# ***Interactive comment on “Analyzing the future climate change of Upper Blue Nile River Basin (UBNRB) using statistical down scaling techniques” by Dagnenet Fenta Mekonnen and Markus Disse***

**Dagnenet Fenta Mekonnen and Markus Disse**

Figure 1: Observed and simulated for precipitation of UBNRB constructed using Thiessen polygon method from the stations

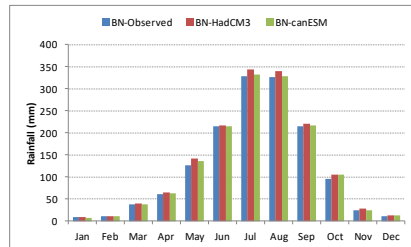
The paper gives a lot of details and too many numbers make it very difficult to follow a clear story line that serves the key message of the paper. E.g., evaluation is made at individual stations, and then for the whole catchment (p11, l23), and large differences were found among the models for the later. What does this mean for the overall uncertainty of the analysis?

In statistical down scaling techniques, that we applied in this study, station level climate variables information of precipitation and temperature are required. These climate variables information can only be found in two ways. Either calculating the areal climate variable information from the observed stations and consider/use it as a single station. Or use directly the information of the stations in and around the catchment for further downscaling and then after calculate the areal average of the whole catchment using Thiessen polygon method. Both approaches were tried in this study and we found that the better agreement between the observed and simulated is in the latter case. Hence, we prefer to use a station level climate information for calibration and validation of our down scaling techniques and also for future prediction of climate change for reliable results. It is not the case that large differences among the models were found due to the fact that evaluation of the whole catchment was done after evaluation of individual stations. The contrary is true, the differences become smoothed (see Figure 4 and Figure 9 for LARS WG and SDSM respectively in the manuscript) and also Fig.1

constructed from the observed and simulated of precipitation.
